Town Of	ALBURG-SWANTON	Bridge No.	2
Highway No.	VT 78	Log Sta.	
		Surv. Sta.

VT 78 OVER MISSISQUOI BAY

DRILLED SHAFT DETAILS

I.G.C. Info.	File No. ZE072ds2	Sheet SS 41 of SS 57
--------------	-------------------	----------------------

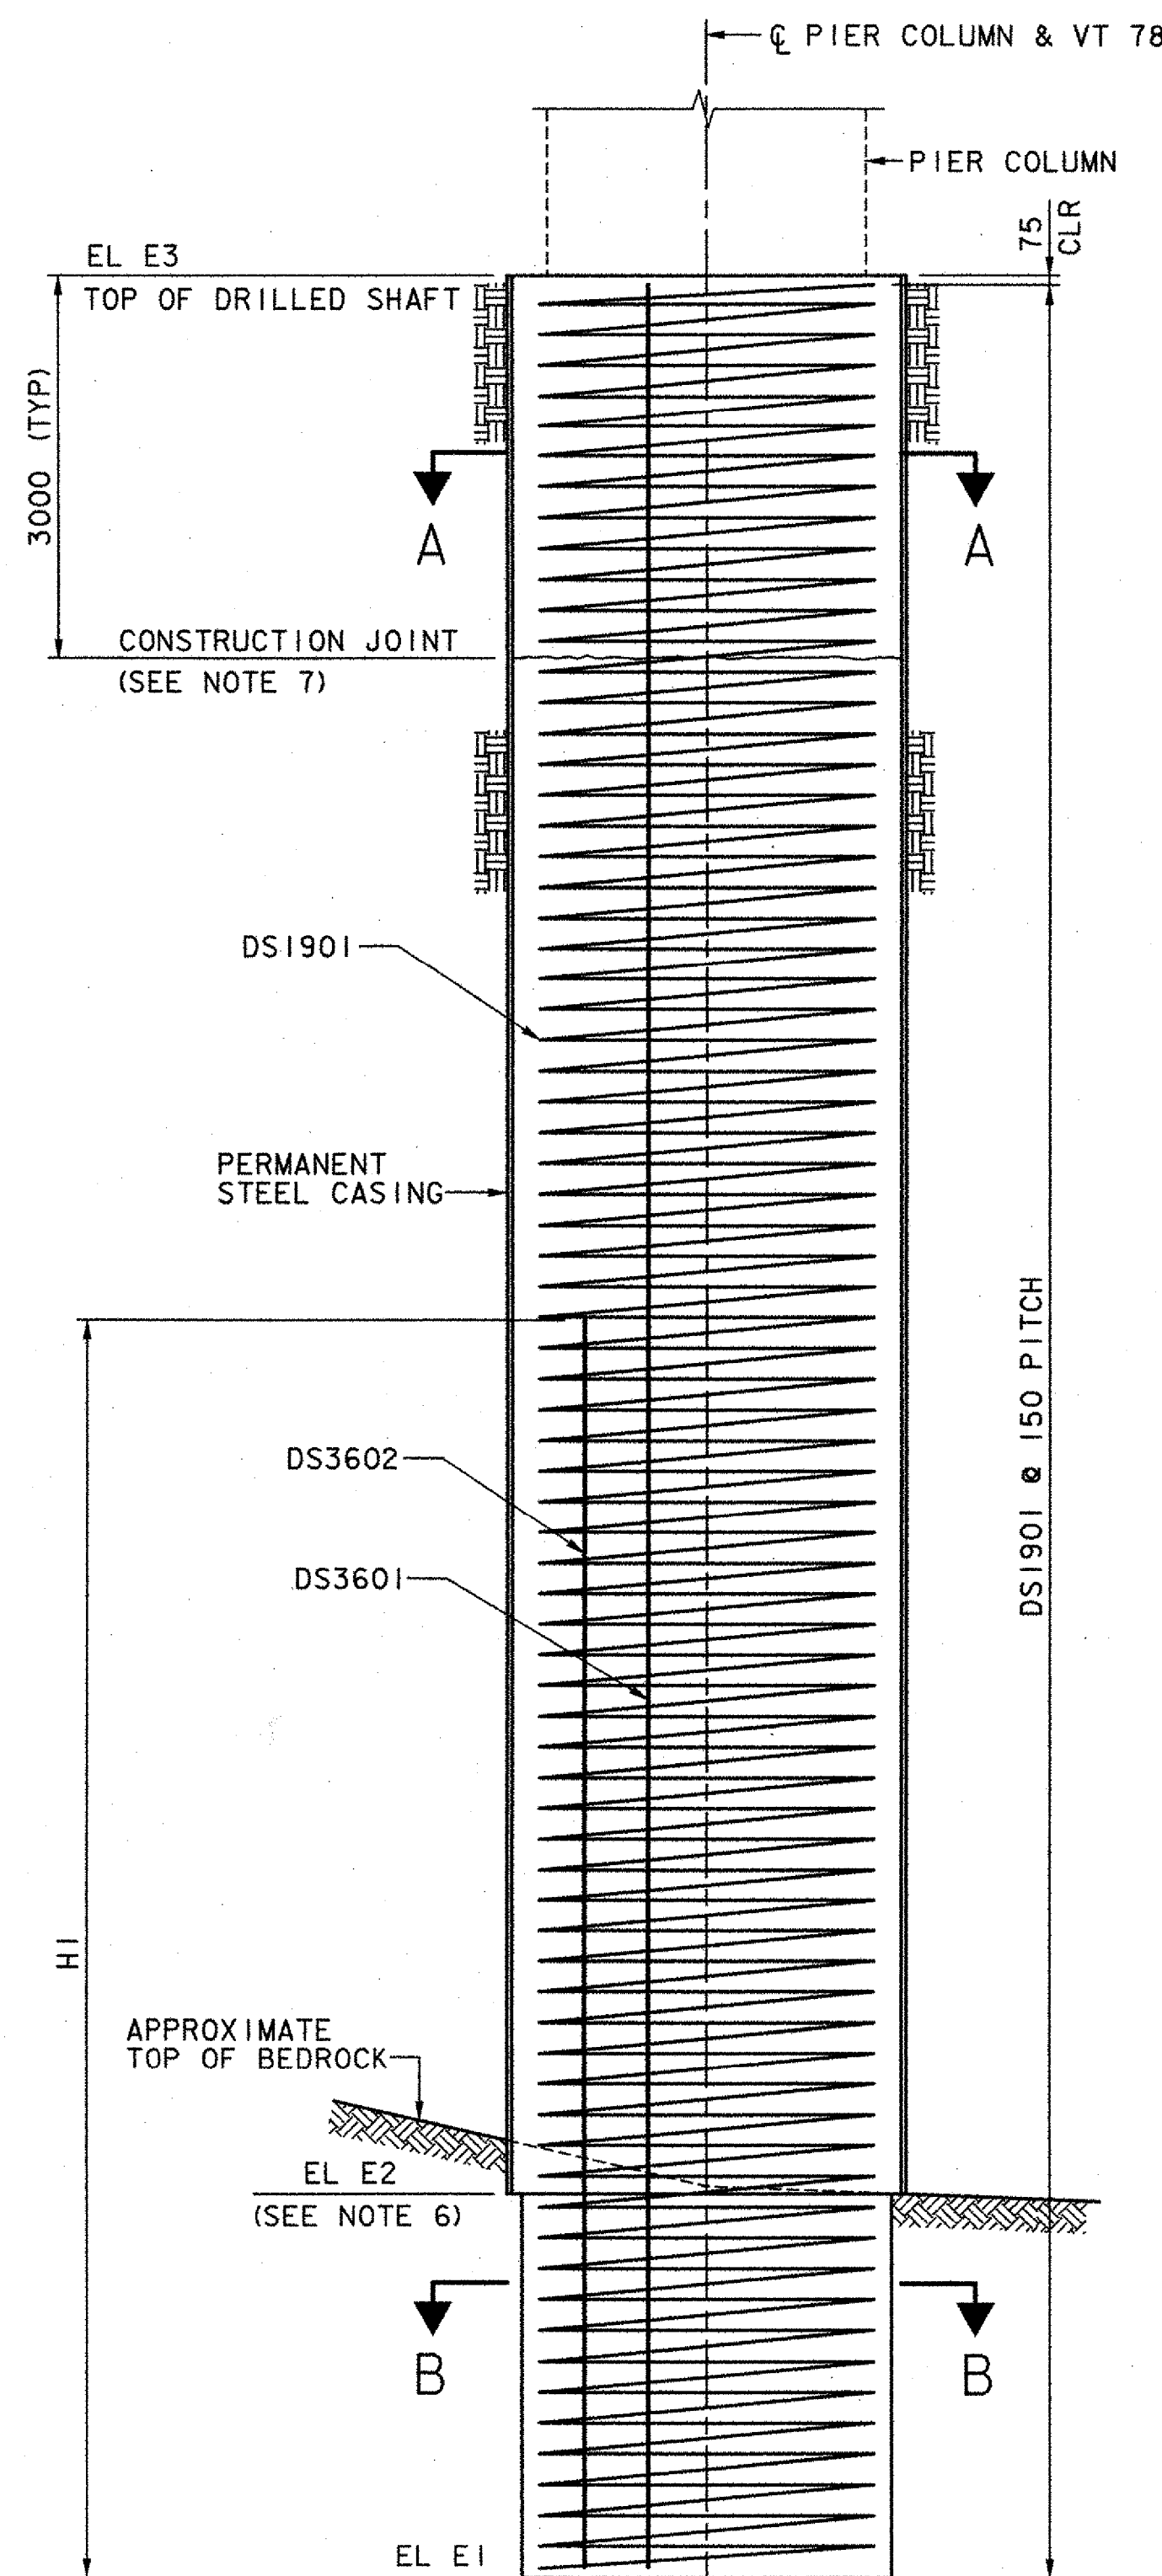
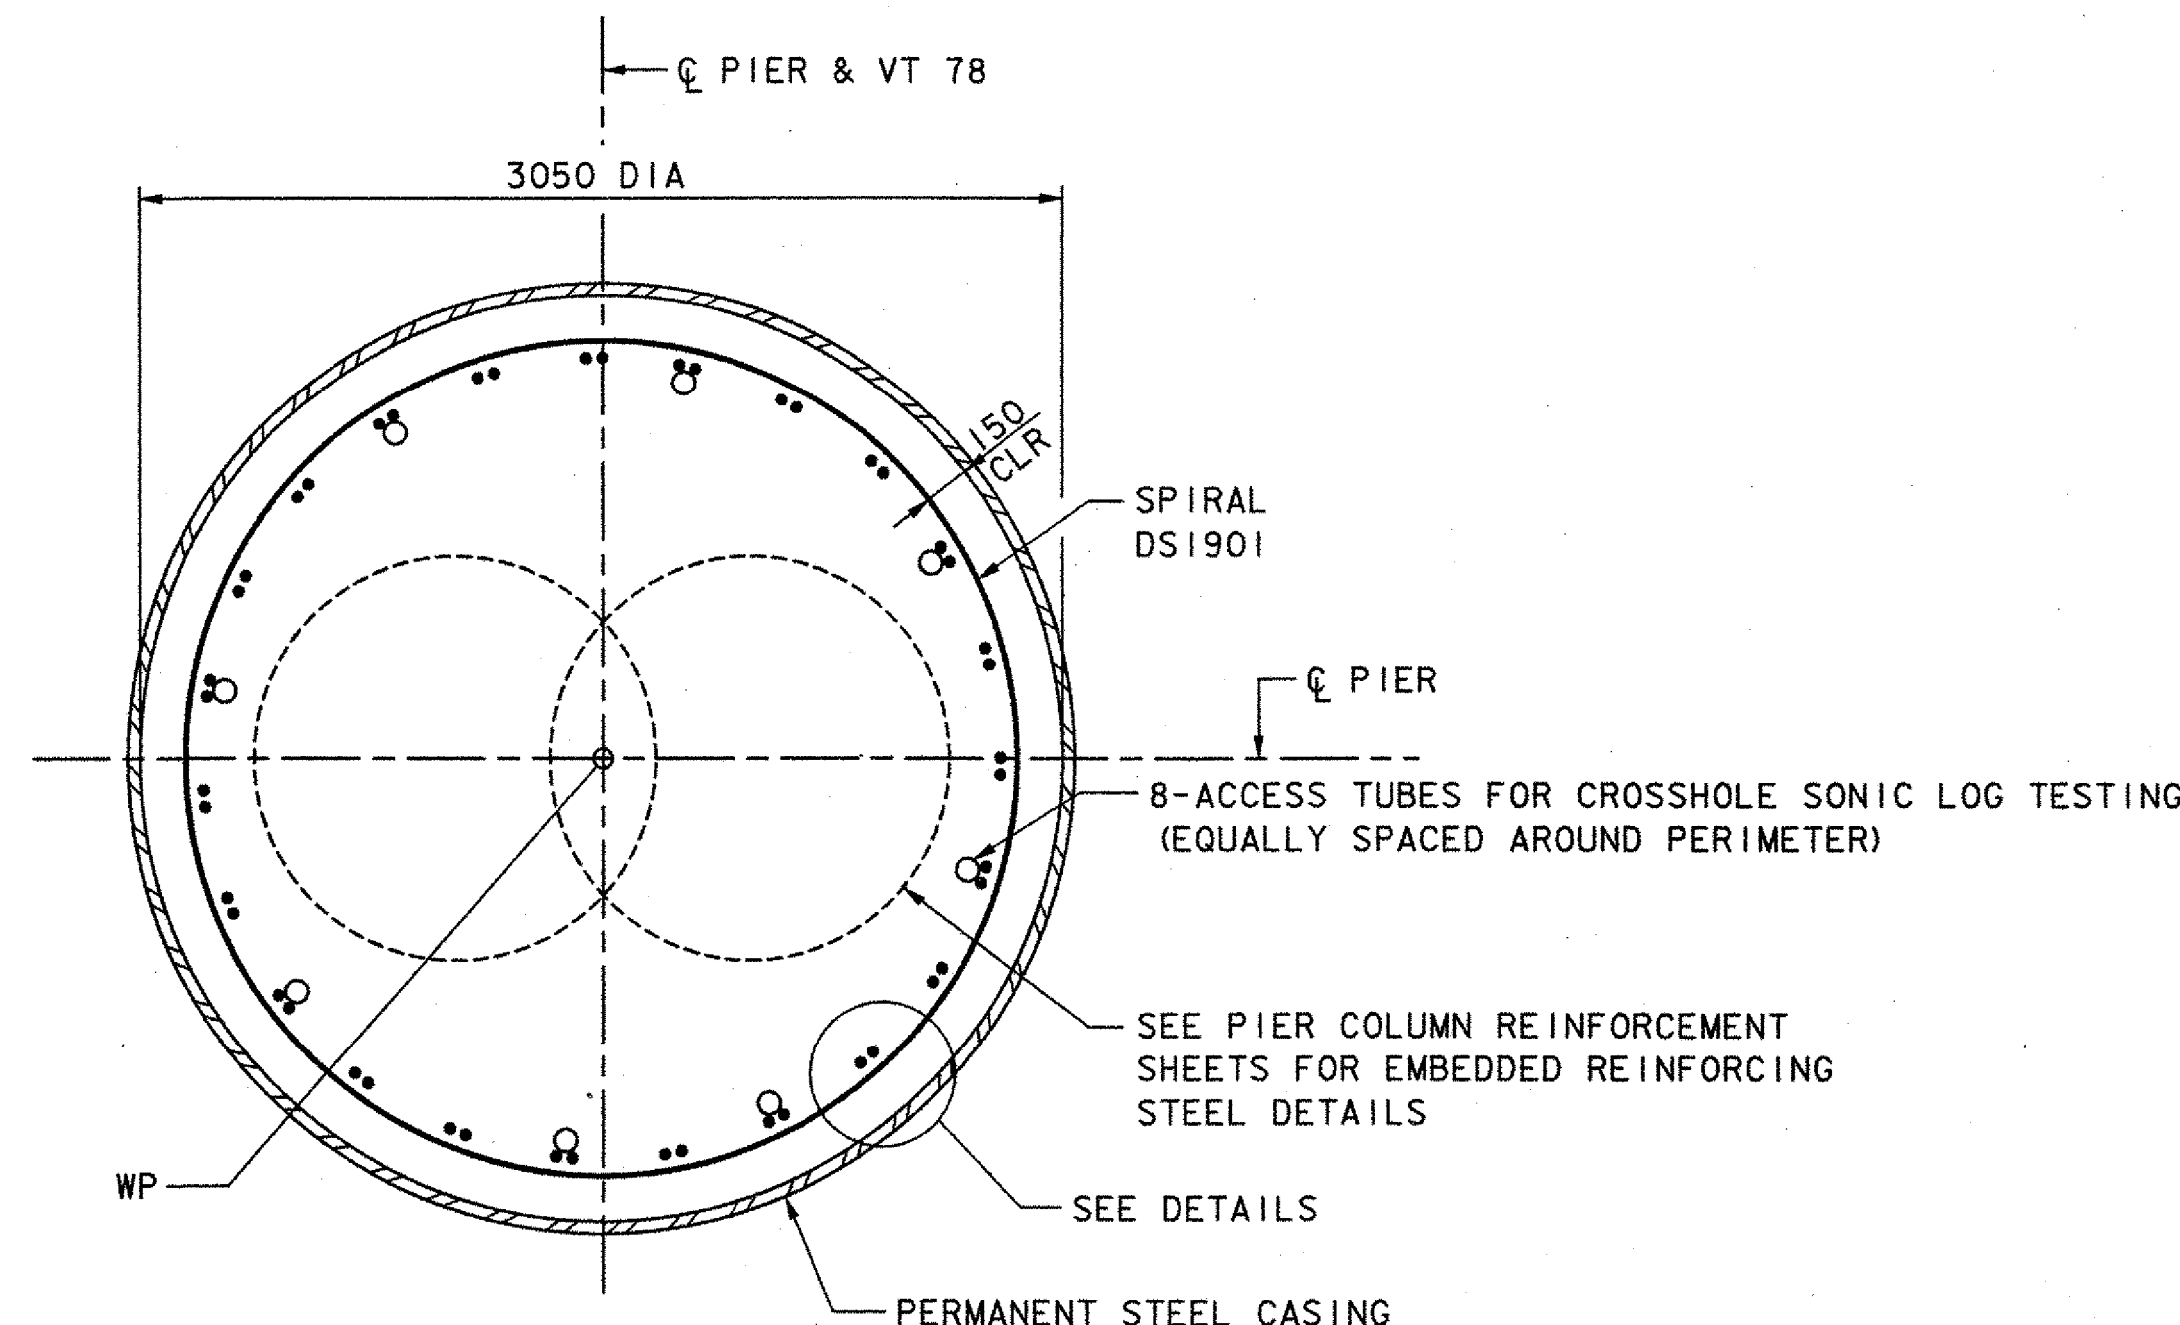
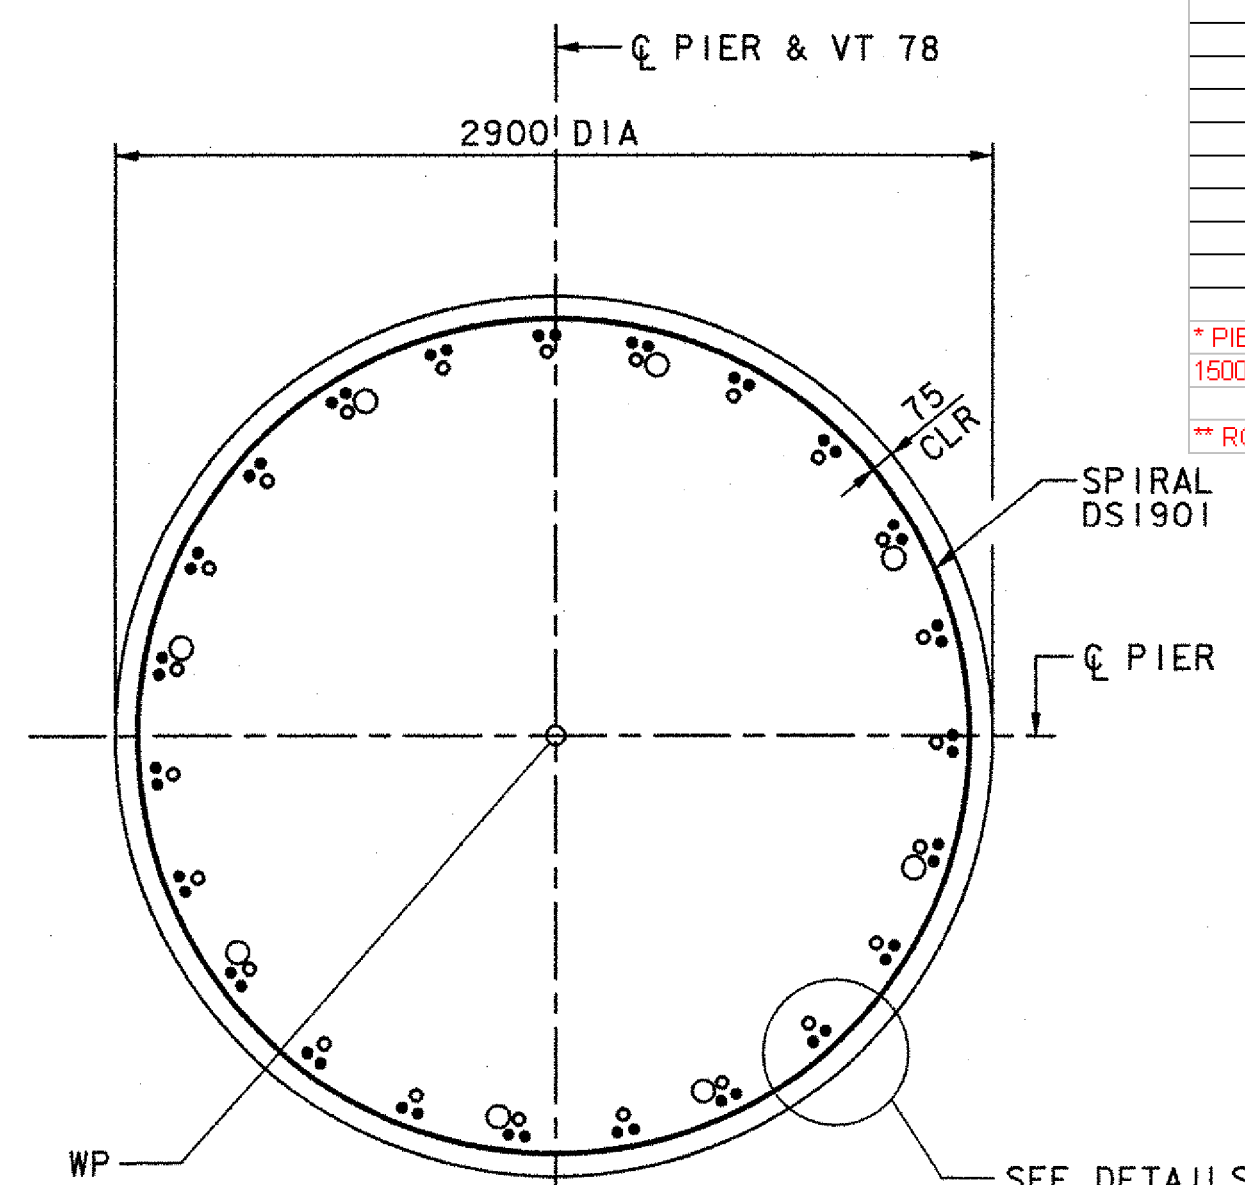
SHAFT #	REV. E2	REV. E1	3602 Bars	3601 Bars
1	22.41	19.31	Added 8 Bars	Splice 1.09m
2	No Change	No Change	No Change	No Change
3	22.24	19.14	No Change	*
4	18.37	15.37	No Change	Splice 2.430m
5	15.22	12.12	No Change	Splice 0.78m
6	11.79	8.79	No Change	Splice 0.81m
7	10.13	7.13	Splice 0.67m	Splice 0.67m
8	19.18	16.18	No Change	Splice 0.82m
9	17.67	14.67	No Bars	2 of 3 Bars Spliced 0.93m
10	18.63	15.63	Added 8 Bars	Splice 1.57m
11	20.2	17.2	No Bars	Splice 0.60m
12	14.32	11.32	No Change	Splice Not Required
13	13.24	10.24	No Change	Splice 0.66m
14	11.49	8.49	No Change	*
15	No Change	No Change	No Change	No Change
16	9.65	6.55	No Change	Extended 1.06m
17	8.3	5.3	No Change	Extended 0.60 m
18	No Change	No Change	No Change	No Change
19	8.12**	5.1	No Change	No Change
20	No Change	No Change	No Change	No Change
21	10.23	7.23	No Change	No Change
22	No Change	No Change	No Change	No Change

* PIER STEM SPIRALS ADDED ON AT BOTTOM OF CAGE TO MAINTAIN 1500 OVERLAP BETWEEN DRILLED SHAFT SPIRALS AND PIER SPIRALS
** ROCK SOCKET SHORTENED TO 3.0 METERS

REVISION TABLE			
NO.	DATE	DESCRIPTION	BY
△	3/9/04	REVISED NO OF BARS	SWJ
